COMMENTS AND RESPONSES

# 201 FOLSOM STREET

SAN FRANCISCO PLANNING DEPARTMENT  
2000.1073E

FIGURE 19a (NEW): REVISED PROJECT FIRST-FLOOR PLAN  
C&R-6

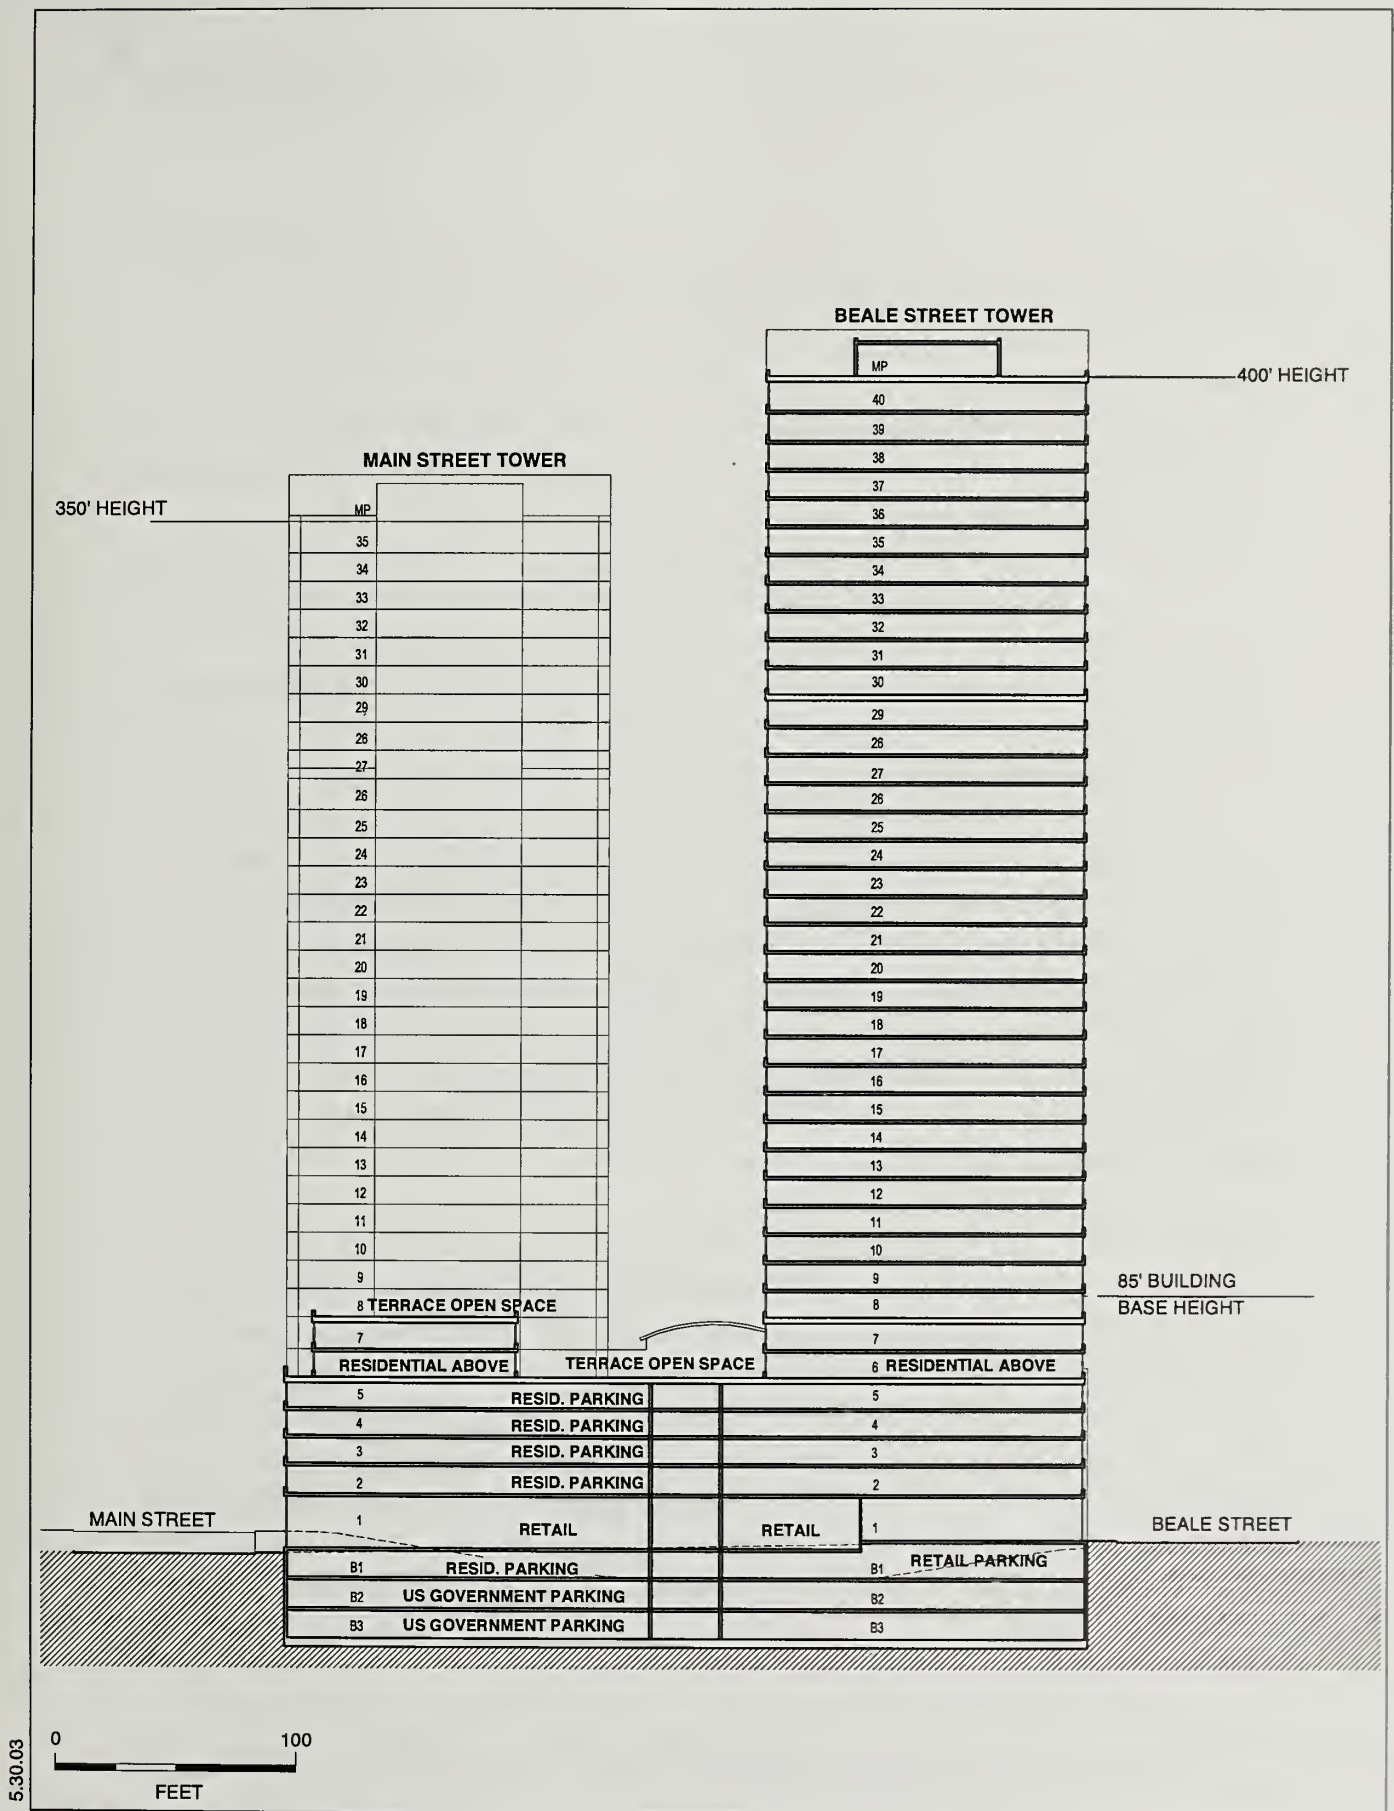
The revised development project would include up to 95 fewer residential units than were analyzed in the Draft EIR, and residential gross floor area would be reduced by about 85,000 gsf. Retail floor area would be increased by about 8,000 gsf. The revised project would include up to 125 fewer parking spaces in three below- and four above-grade (a total of seven) levels; there would be one less above-grade parking level. The changes in parking would include about 32 fewer spaces for the commercial use, up to 95 fewer spaces for the residential use, and two additional spaces for use by the U.S. Government. Parking spaces designated for the U.S. Government would continue to be on the two lowest below-grade levels. (See Figure 19a: Revised Project First-Floor Plan, and Figure 19b: Revised Project Building Section.)

In the revised project, the pedestrian bridge proposed to provide direct access to the U.S. Government parking from the USPS Annex via elevator would be at the second instead of the third level. The revised project would provide one less loading space; trash facilities would be located adjacent to instead of within the loading docks area.

FIGURE C&R-B: ALTERNATIVE C VIEWS

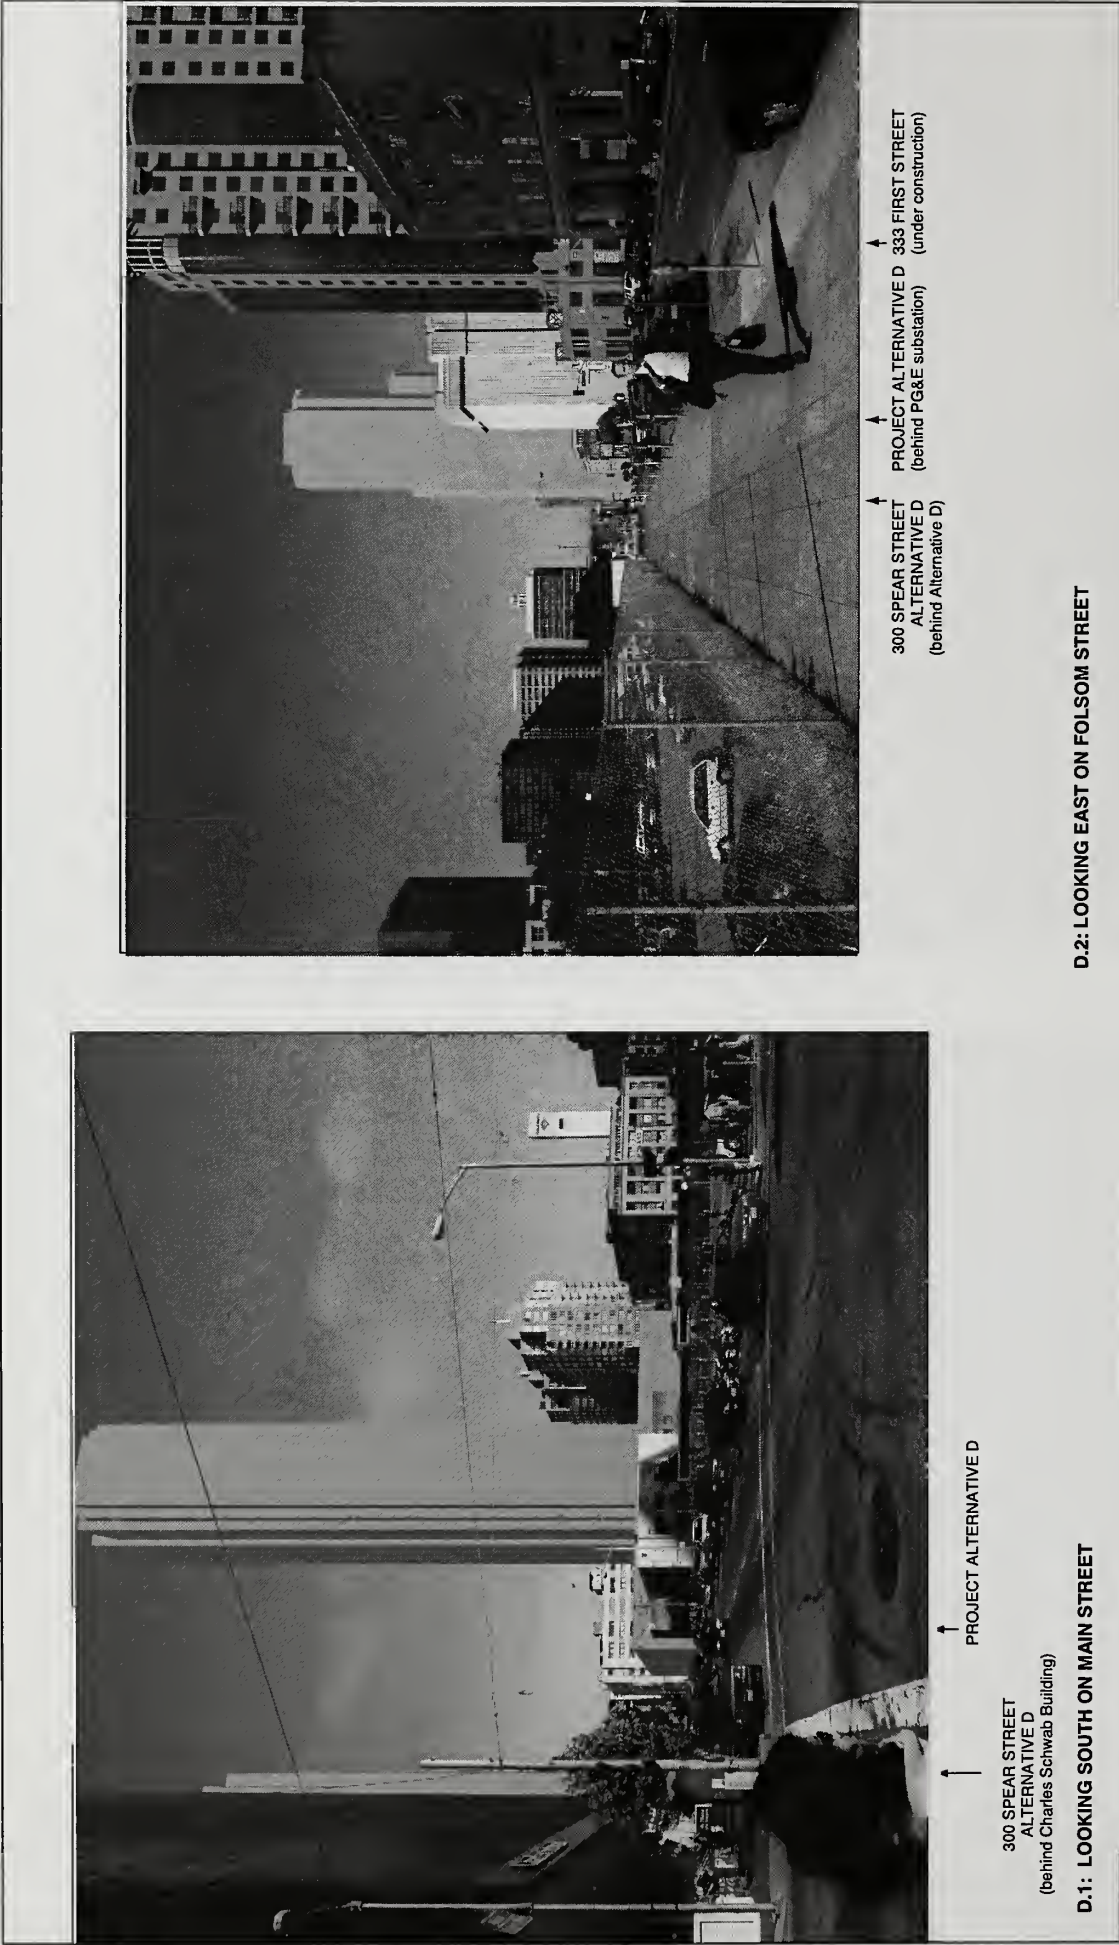
In response to the commentor's request for additional figures to assess the visual impact of the alternatives, an additional section for Alternative B is provided. This figure is added to the EIR as Figure 34a: Alternative B Section, and is shown on p. C&R-37. Photo simulations of Alternatives B, C and D are also provided on the following pages to assist the reader (see Figure C&R-A: Alternative B Views; Figure C&R-B: Alternative C Views; and Figure C&R-C: Alternative D Views). The visual impacts of Alternative B, C, and D are discussed on pp. 182, 187 and 191 of the EIR, respectively. The commentor further requests massing models and/or photo simulations to illustrate the currently allowable height and bulk limits for the site. Since Alternatives B and C reflect development conforming to existing height and bulk restrictions, this request is met in Figures C&R-A and C&R-B, provided on pp. C&R-38 and C&R-39.

**FIGURE 21 (REVISED): EXISTING, UNDER-CONSTRUCTION, APPROVED, AND PROPOSED RESIDENTIAL DEVELOPMENTS IN RINCON HILL SUD**

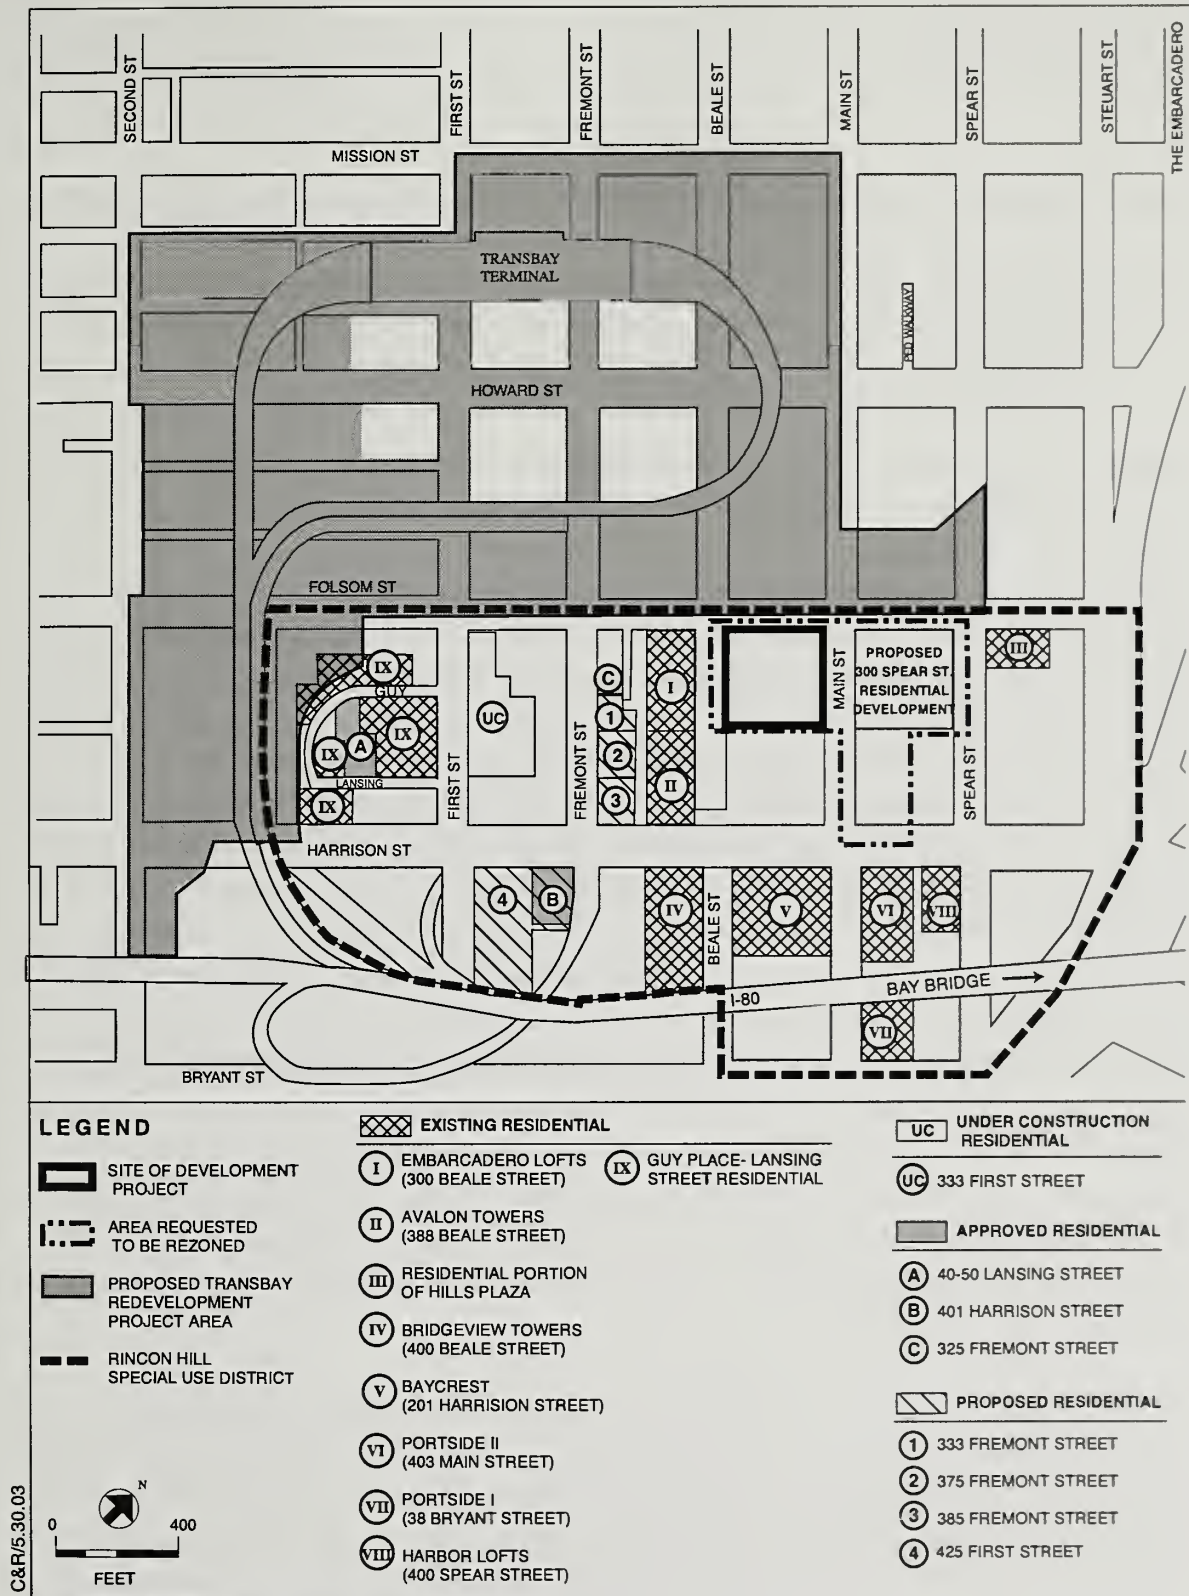
The Land Use, Zoning and Plans section of the EIR acknowledges the planning effort in the proposed Transbay Redevelopment Project Area on pp. 70-71. The EIR describes in detail existing and proposed residential development in the vicinity (see pp. 71-73 and Figure 21, p. 59). Figure 21 in the EIR is hereby updated to add proposed projects and reflect recent changes in nearby residential development (see Figure 21: Existing, Under-Construction,

Approved, and Proposed Residential Developments in the Rincon Hill SUD). As shown on Figure 21, the residential developments at 300 Spear Street, 40-50 Lansing Street, 333 Fremont Street, 375 Fremont Street, 385 Fremont Street, and 425 First Street projects are among the recently proposed residential development in the Rincon Hill SUD area.<sup>1</sup> Additional discussion of residential development is also provided under Land Use, Residential Density, pp. C&R-19-C&R-22.

Residential developments in the near and mid-vicinity (within three to four blocks) of the requested rezoning area are the predominant uses to the south and west. They include Embarcadero Lofts (at 300 Beale Street), Avalon Towers (at 388 Beale Street), an approved residential development at 325 Fremont Street, **proposed residential developments at 333 Fremont Street, 375 Fremont Street, and 385 Fremont Street**, a residential development under construction at 333 First Street, **existing residential buildings surrounding Guy Place and Lansing Street**, and an approved residential development at **40-50 Lansing Street** west of the requested rezoning area across Beale Street; and Harbor Lofts (at 400 Spear Street), **Portside I (at 38 Bryant Street)**, Portside II (at 403 Main Street), Baycrest (at 201 Harrison Street), Bridge View Towers at 400 Beale Street, an approved residential development at 401 Harrison Street, and a **proposed residential development at 425 First Street** south of the requesting rezoning area across Harrison Street. (See Figure 21: Existing, Under-Construction, Approved, and Proposed Residential Developments in Project Vicinity.)
